CITY OF ALBUQUERQUE

**Re: West Mesa High School Parking Lot Grading and Drainage Plan
Engineer's Stamp dated 4-13-10 (J10/D005)**

Based upon the information provided in your submittal received 4-14-10, the above referenced plan is approved for Grading Permit and Paving Permit.

A1 OVERALL GRADING & DRAINAGE PLAN
SCALE: 1"=100'

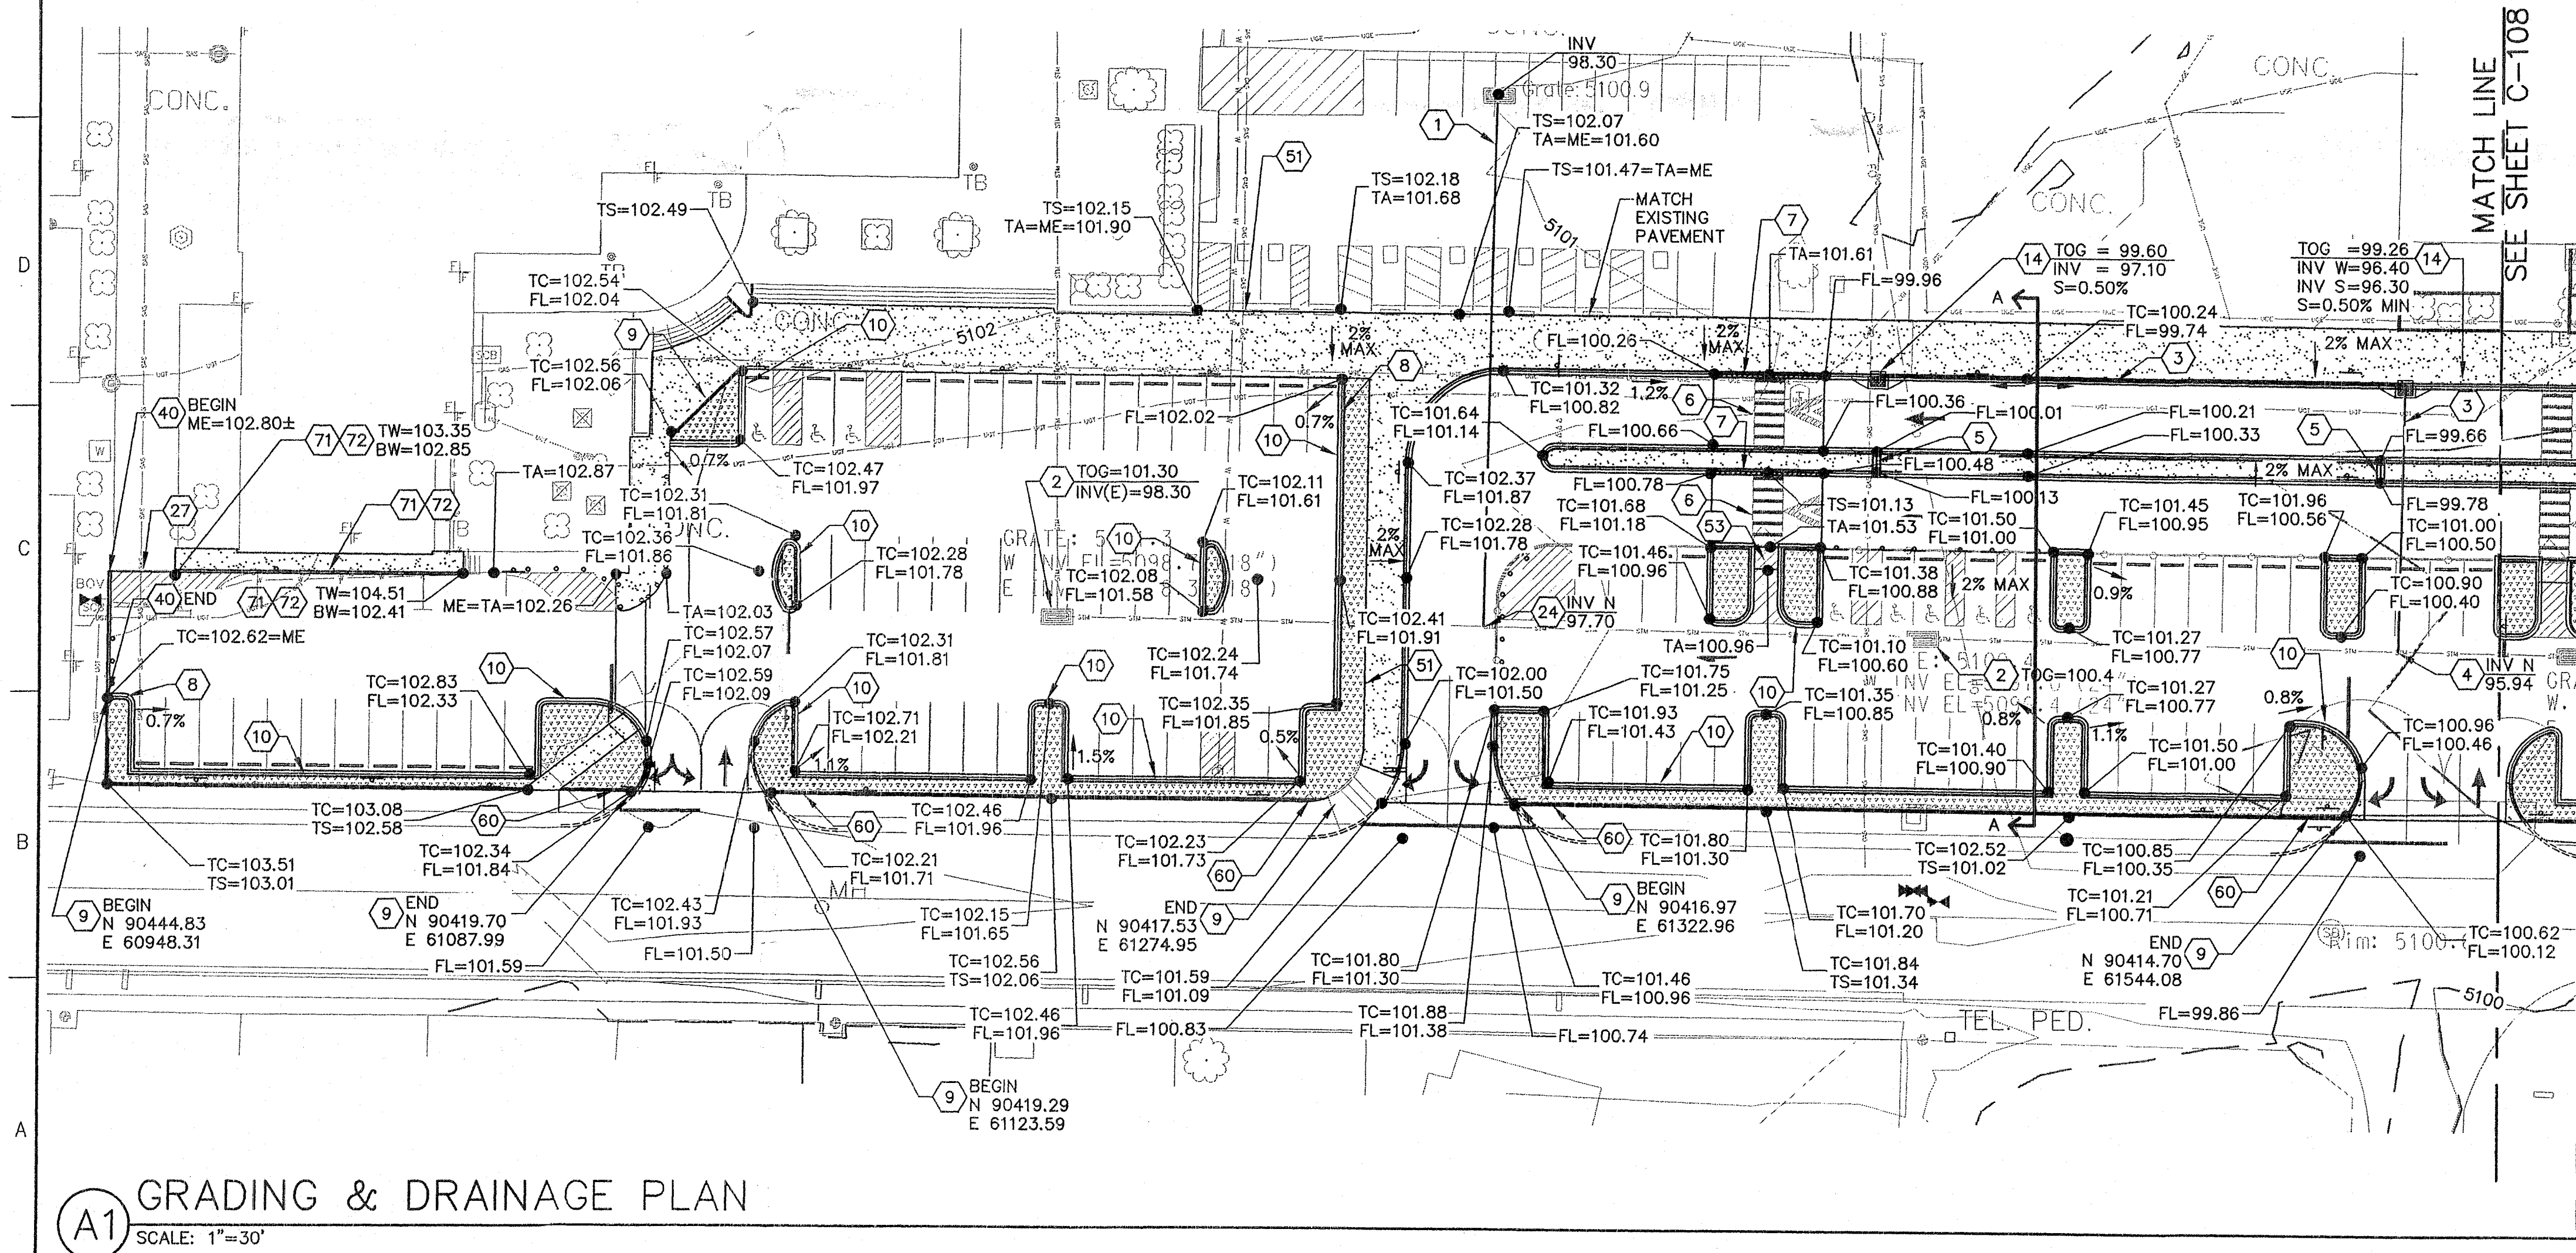
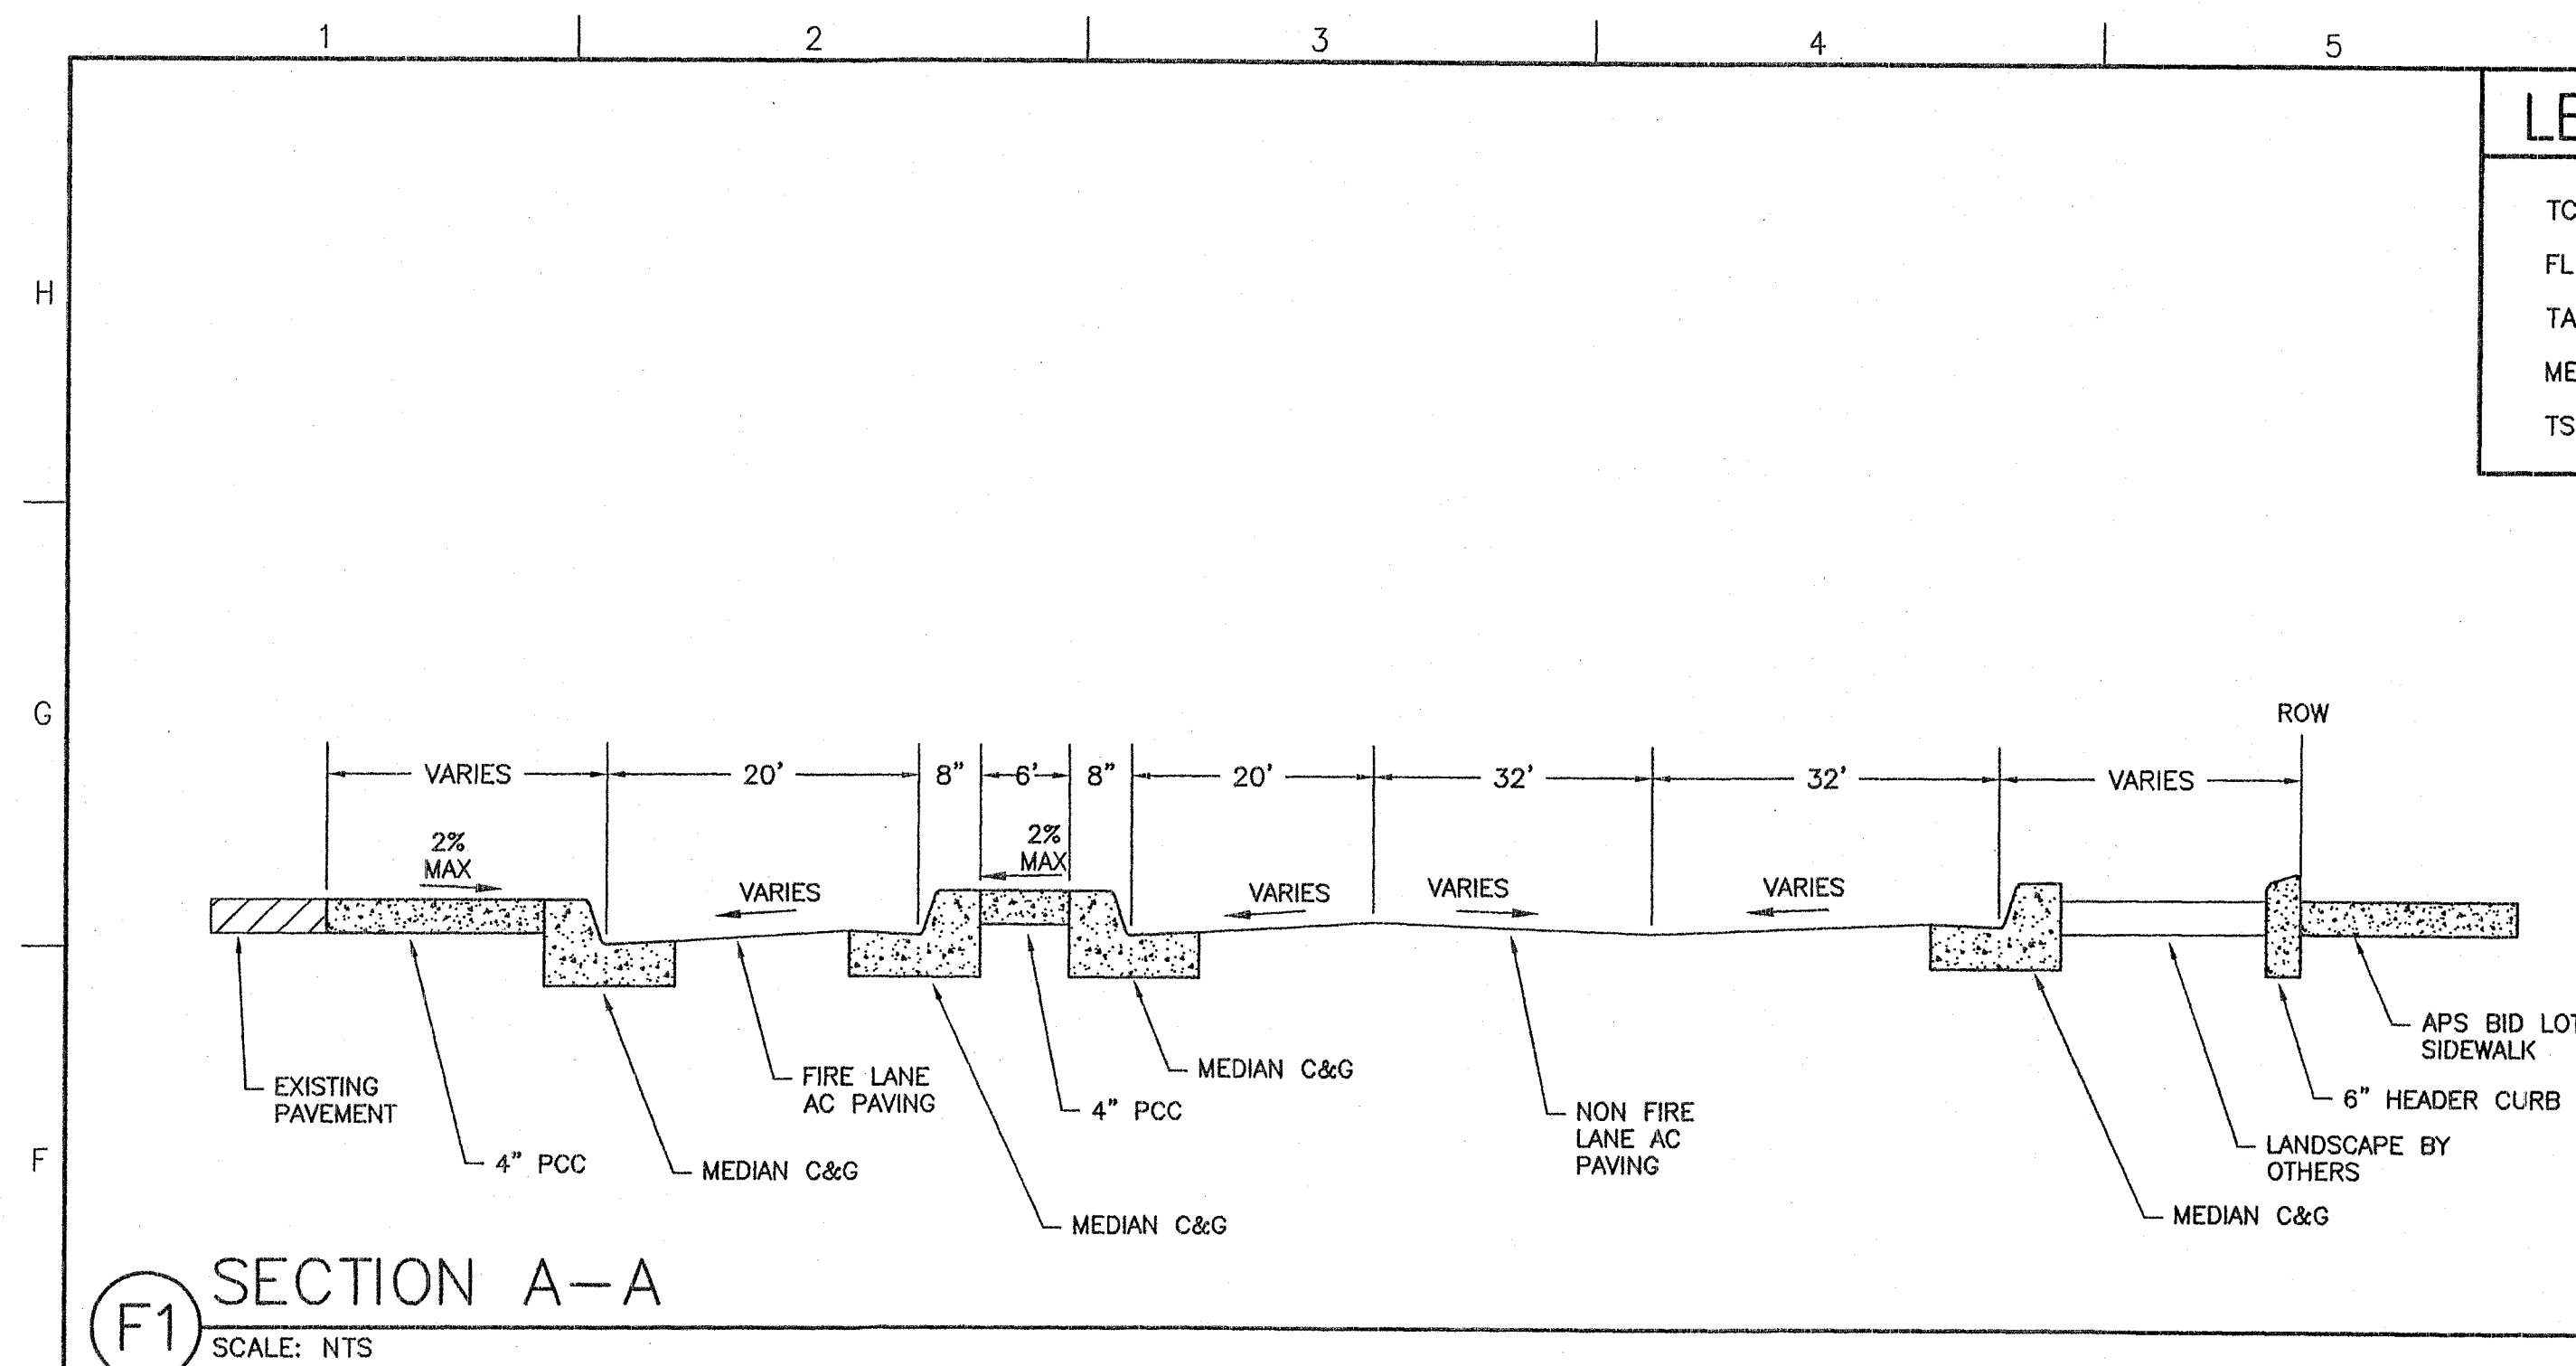
Please verify the inverts for the existing and proposed storm drain. There may be an inconsistency between the StormCad data and the Grading Plan.
